SUBJECT: TEC Peer Review  
125 Merrimack Street  
Wan Yan, LLC

Greenman-Pedersen, Inc. (GPI) is in receipt of a letter from TEC, Inc. (TEC) dated May 7, 2021 containing review comments pertinent to the above referenced site plan application. Those comments, followed by our responses in **bold**, are provided below.

125 MERRIMACK STREET  
METHUEN, MASSACHUSETTS

## AASHTO Recommended Sight Distance Summary (Passenger Vehicles)

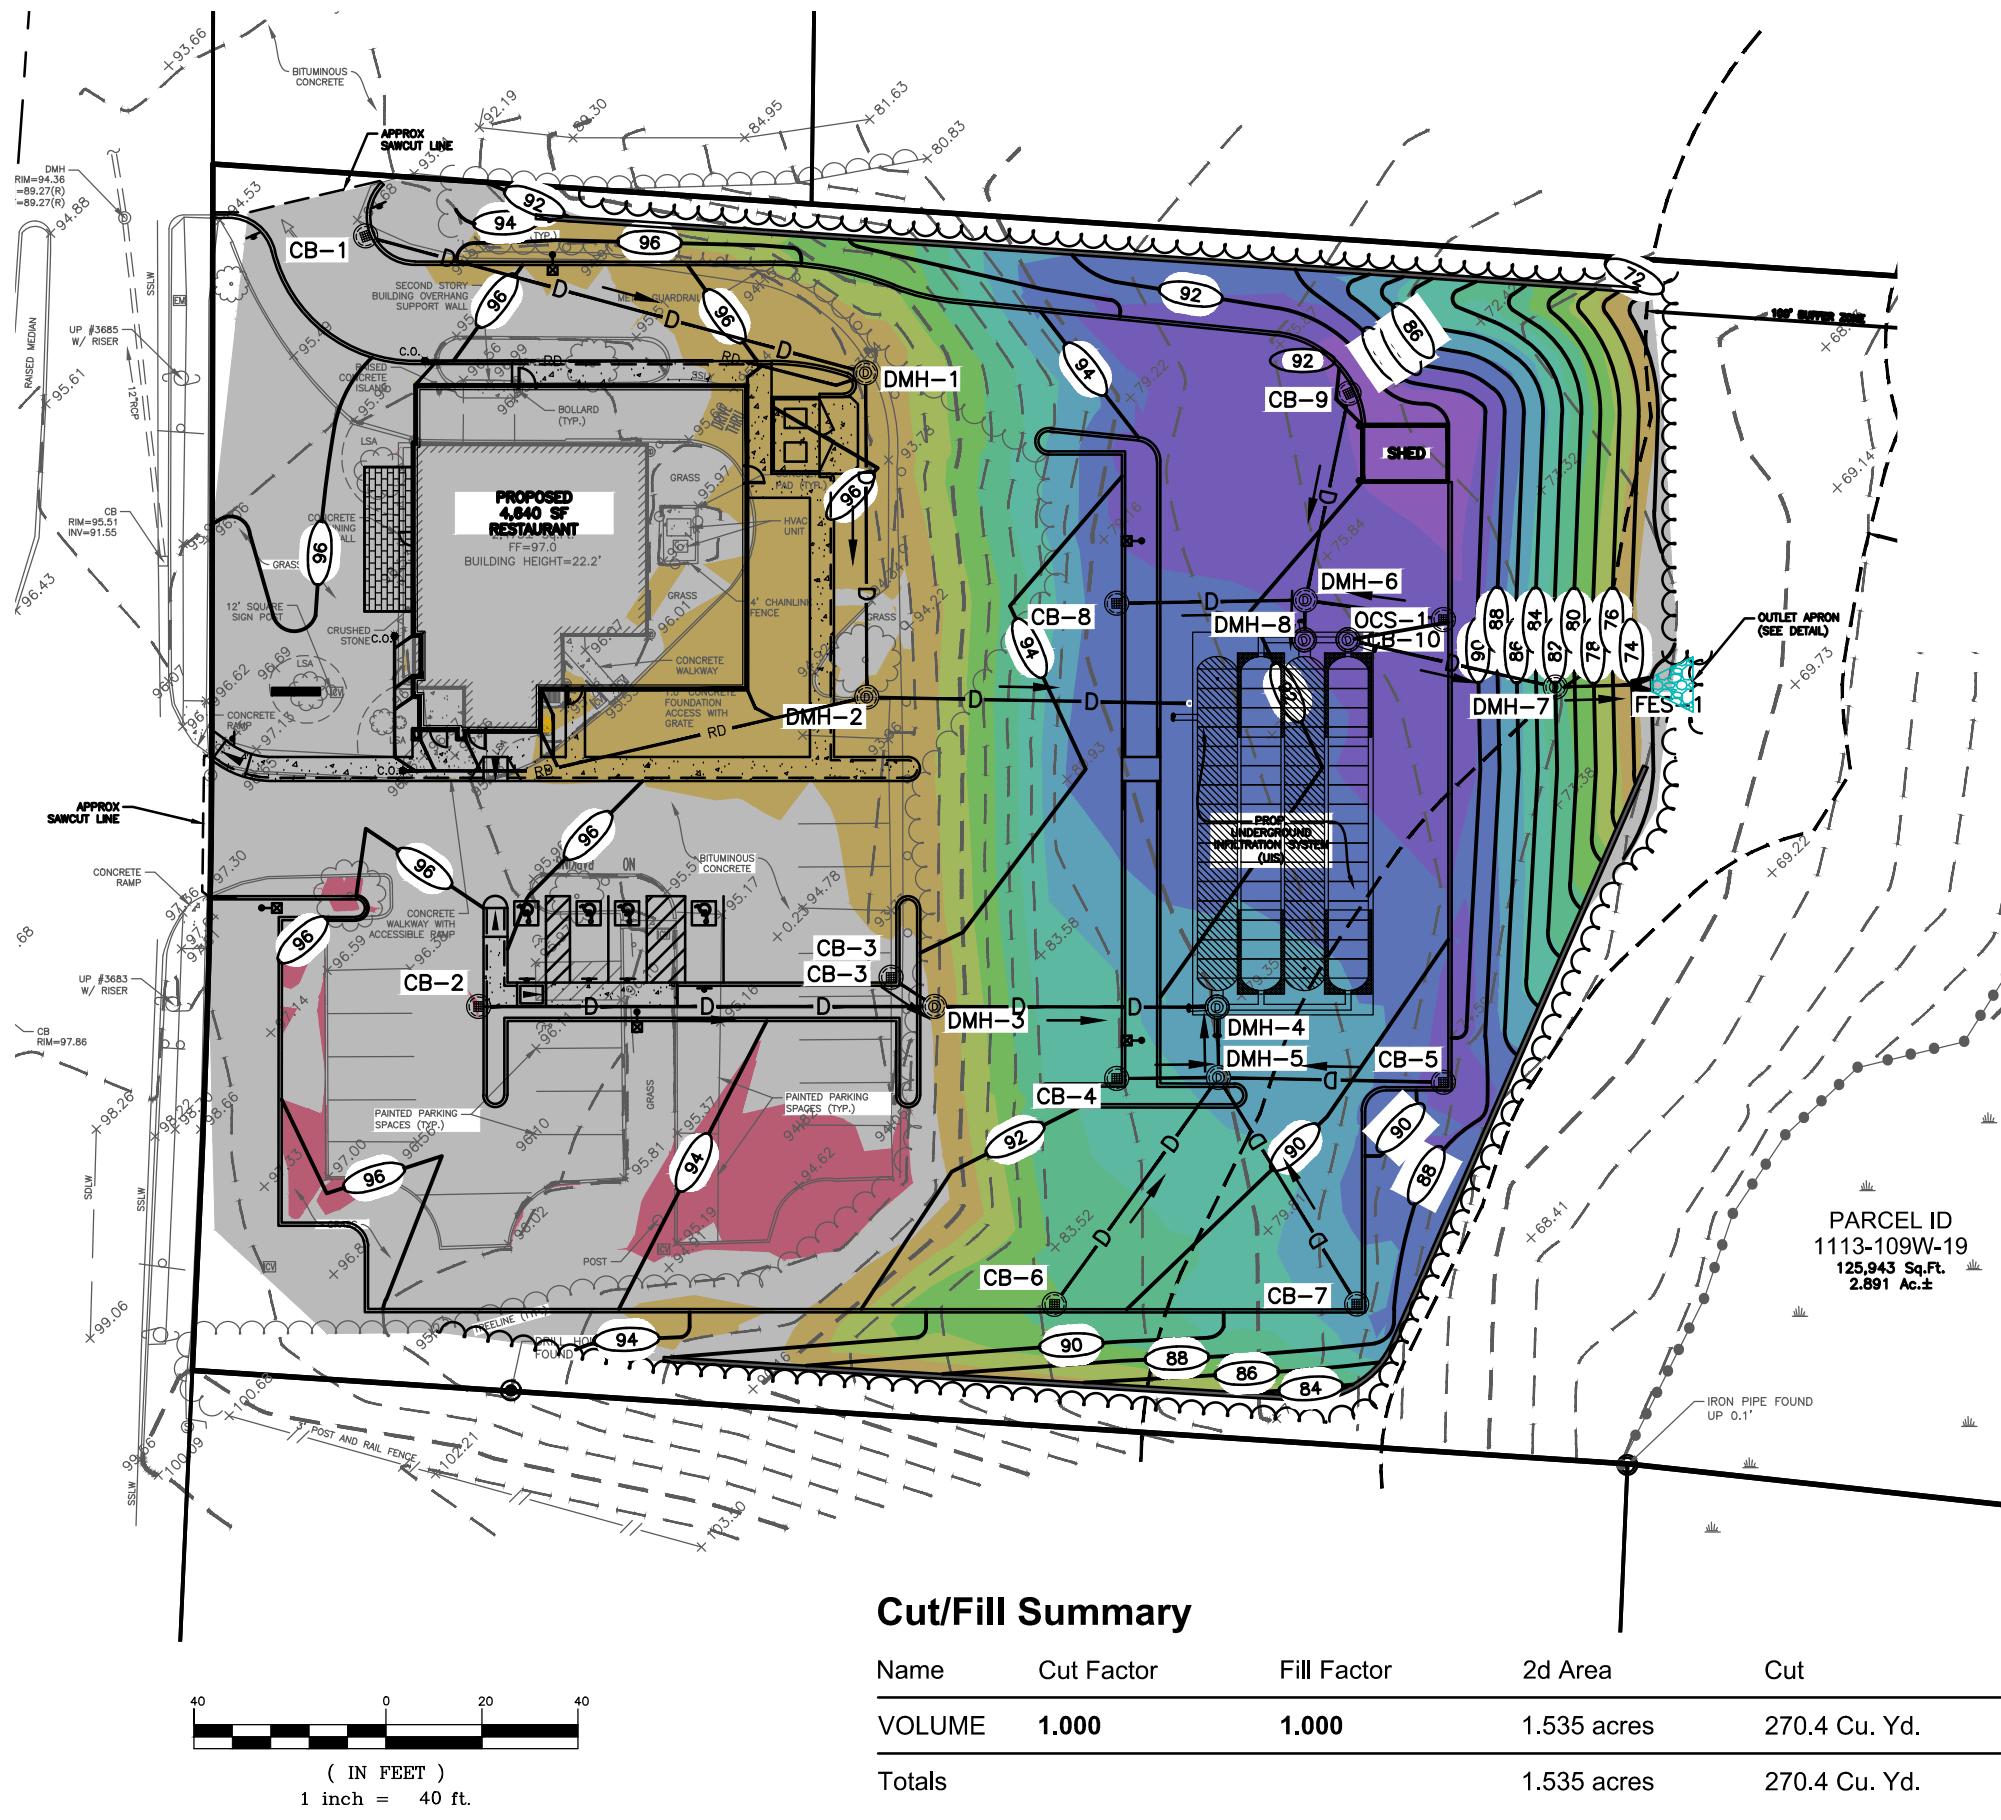
18. The Applicant should confirm on the Site Plans that the sight distance triangles are adequate in both directions from the Merrimack Street driveway. The Site Plans should indicate the areas within those sight triangles where vegetation and signage are to be removed or kept low.

**As requested, the sight line triangles have been added to the Site Plan. The sight distance calculations are based on the posted speed limit of the roadway. The calculations are attached to this letter. As shown, there is no vegetation or signage within the sight line triangles that would have to be removed.**
